**CITY OF TEMPE
DEVELOPMENT REVIEW COMMISSION**

**Meeting Date: 08/25/2014
Agenda Item: 3**

ACTION: Request for a Development Plan Review consisting of a new one story 8154 sf office/warehouse building for AME ELECTRIC, located at 7120 South Priest Drive. The applicant is Eric Liebsohn + Associates, LTD

DPR14133

CASE: SPR14068
SHEET NUMBER
A-3
4 OF 4

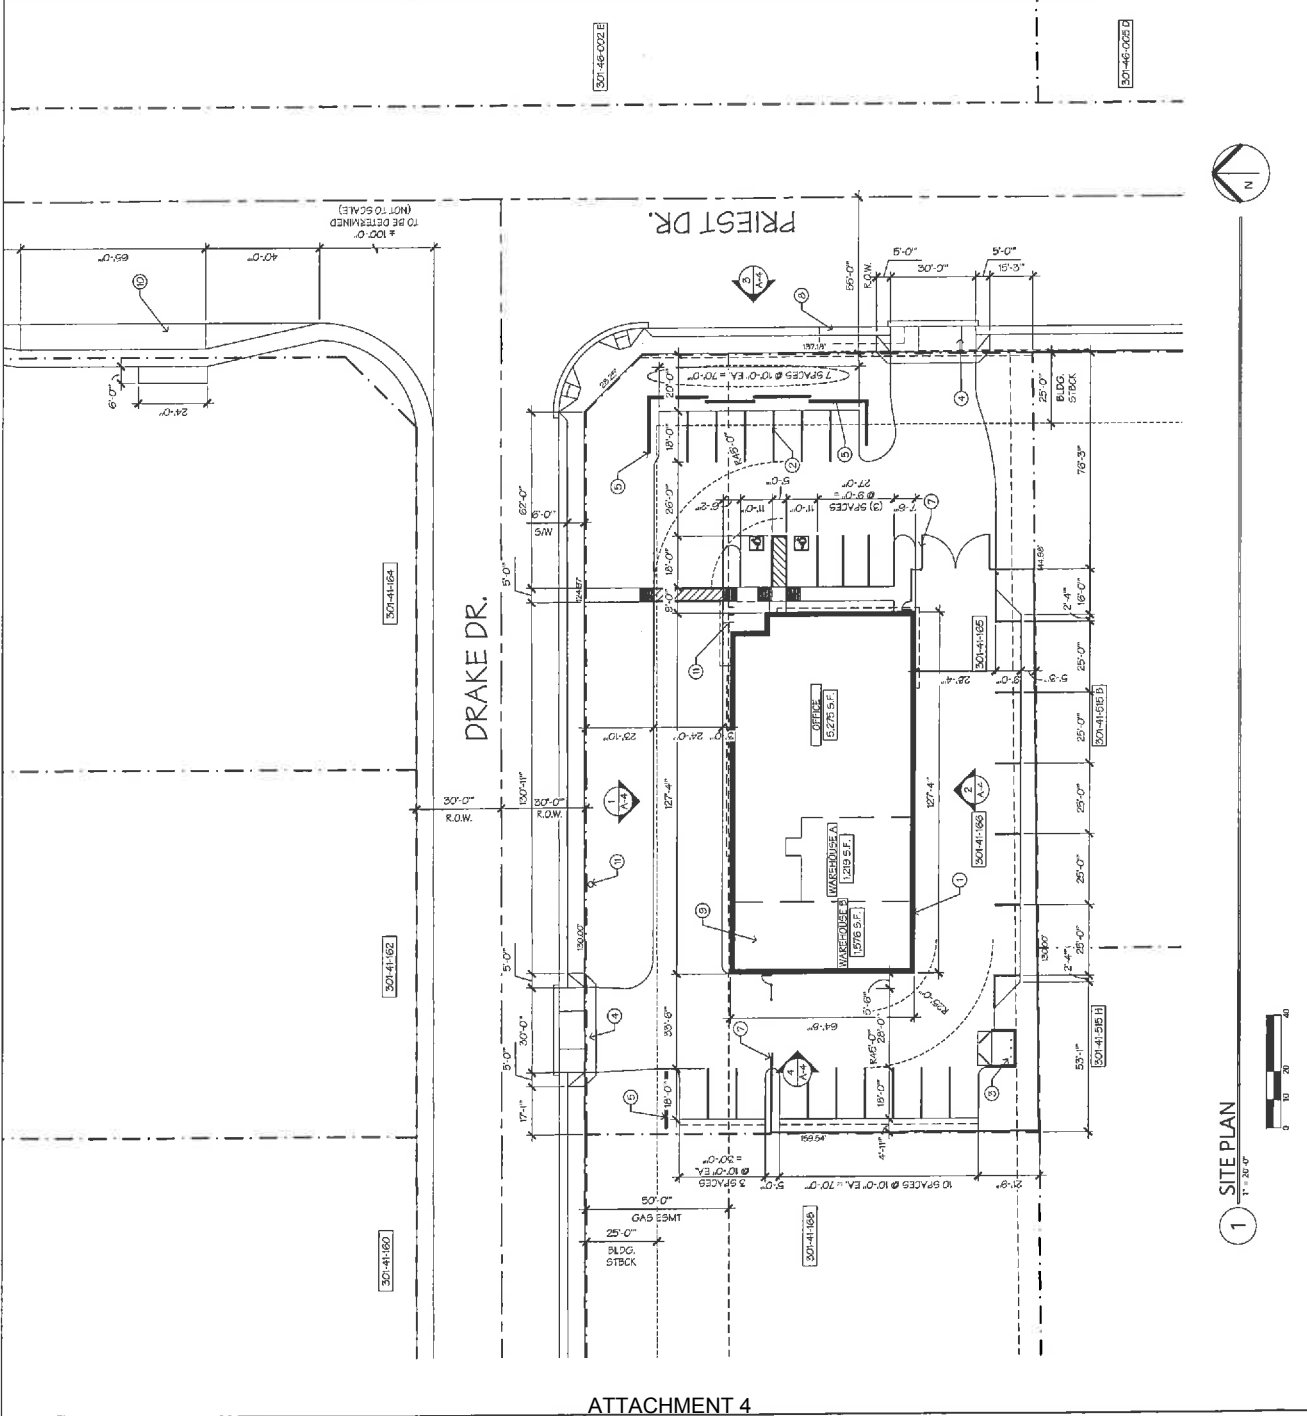
The proposed site plan, places the building in the center of the lot abutting the easement with the maneuvering and consisting of surface parking area surrounding the building. The southwest portion of the site will be gated to secure the loading area for the suites. The allowance of access to Priest Drive frontage was instrumental in development of the site. A non-vehicular access easement previously existed along Priest Drive frontage.

1. Provide/Maintain an 8'-0" wide public sidewalk along arterial roadways, or as required by Traffic Engineering Design Criteria and Standard Details.
2. Provide gates of steel vertical picket, steel mesh, steel panel or similar construction. Where a gate has a screen function and is completely opaque, provide vision portals for visual surveillance. Provide gates of height that match that of the adjacent enclosure walls. Review gate hardware with Building Safety and Fire staff and design gate to resolve lock and emergency ingress/egress features that may be required.

3. Utility equipment boxes for this development shall be finished in a neutral color (subject to utility provider approval) that compliments the coloring of the buildings.

4. Place exterior, freestanding reduced pressure and double check backflow assemblies in pre-manufactured, pre-finished, lockable cages (one assembly per cage). If backflow prevention or similar device is for a 3" or greater water line, delete cage and provide a masonry or concrete screen wall following the requirements of Standard Detail T-214.

PRELIMINARY LANDSCAPE PLAN

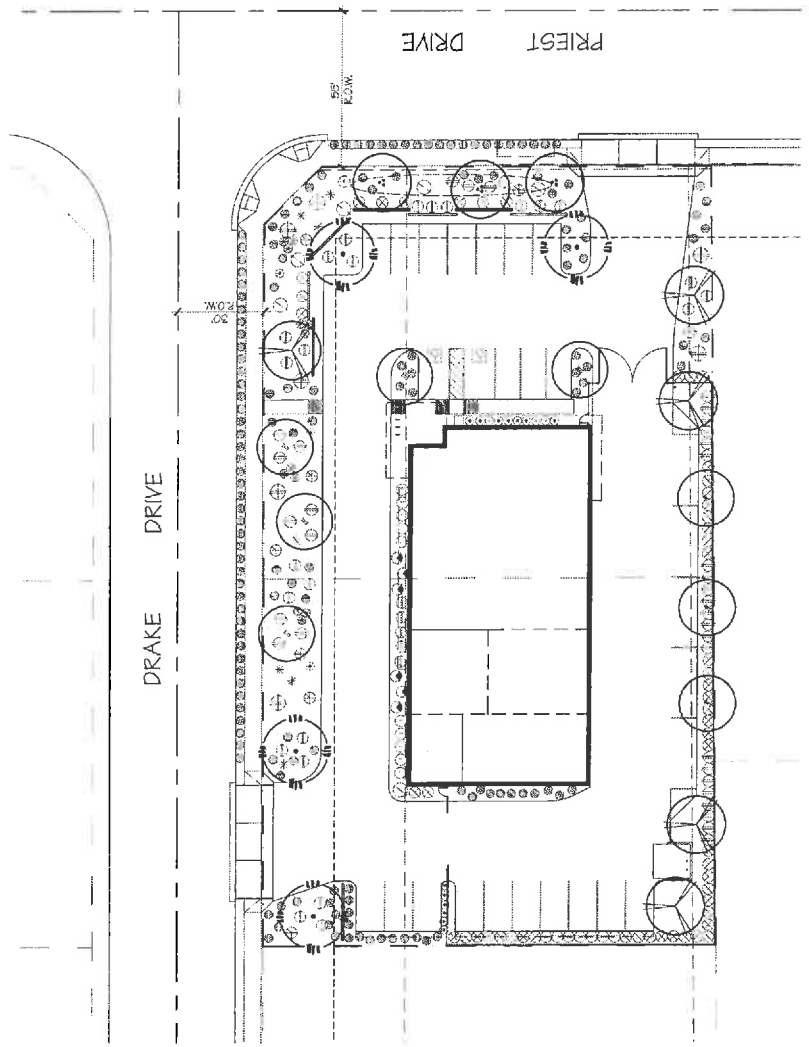
The proposed landscape plan will provide an improved streetscape. The project area will introduce a low-water use landscape motif, consisting of Blue Palo Verde trees at the street front and Desert Museum species within the parking lot.

12. The plant palette is approved as proposed and specified on the landscape plan. Any additions or modifications may be submitted for review during building plan check process.

13. Irrigation notes:
 - a. Provide pipe distribution system of buried rigid (polyvinylchloride), not flexible (polyethylene). Use of schedule 40 PVC mainline and class 315 PVC 1/2" feeder line is acceptable. Class 200 PVC feeder line may be used for sizes greater than 1/2". Provide details of water distribution system.

14. Include requirement to de-compact soil in planting areas on site and in public right of way and remove construction debris from planting areas prior to landscape installation.

15. Top dress planting areas with a rock or decomposed granite application. Provide rock or decomposed granite of 2" uniform thickness. Provide pre-emergence weed control application and do not underlay rock or decomposed granite application with plastic.

16. Trees shall be planted a minimum of 12'-0" from any existing or proposed public water or sewer lines located on-site. Trees near the main water or sewer lines located within the right of way shall be planted at least 20'-0" away. Final approval subject to determination by the Public Works, Water Utilities Division.
